**XT Series****April 2016****Version 124 Firmware Update**

Version 124 (4/6/16) firmware is now available for download on the DMP Dealer Direct Website at <http://dmp.com/dealer>.

**Disarm/Disable Default Changed**

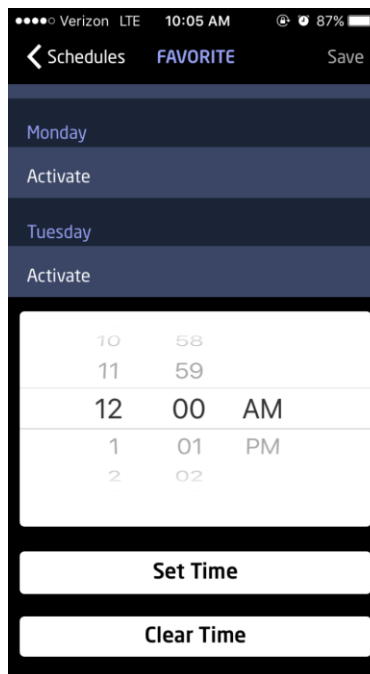
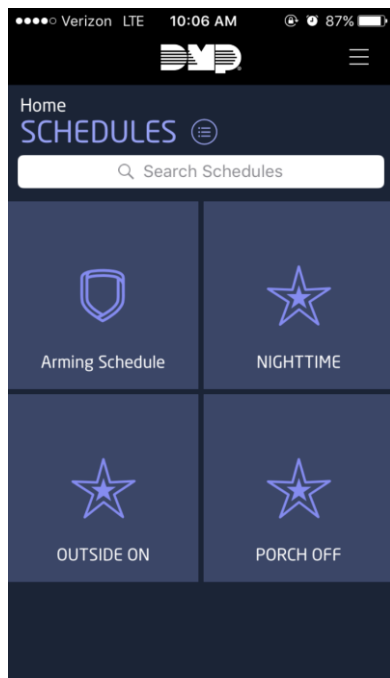
The default setting for the Disarm/Disable prompt in Zone Information has been updated from “YES” to “NO” in 1101, 1102, 1103, and 1106 universal transmitters.

**Note:** The Disarm/Disable option displays for 1101, 1102, and 1106 transmitters, however, it is not supported.
